Access Compliance Report

Public Rights-of-Way

Intersection ID: 3584	Main Street: DIXIE ANN DR	Cross Street: CHOWNING TAVERN LN	Location: SW
ADA ID: 59E75C1568D7	Ramp Type: PerpDiag	Initial Pass/Fail: Fail	Overall Compliance: No
Severity Score: 8.75			
Codes/Mitigation Info/Possible Solution		Field Measurements/Component Compliance

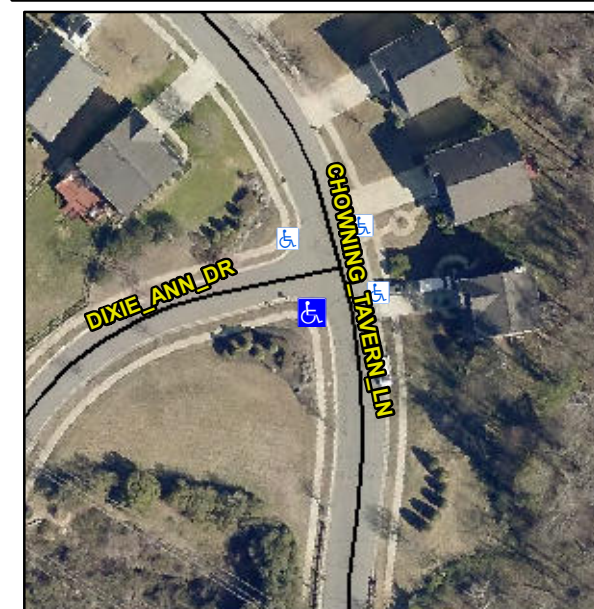
Not Found, R304.5.1

Remove & Replace Curb Ramp With Two New Directional Ramps or Equivalent.
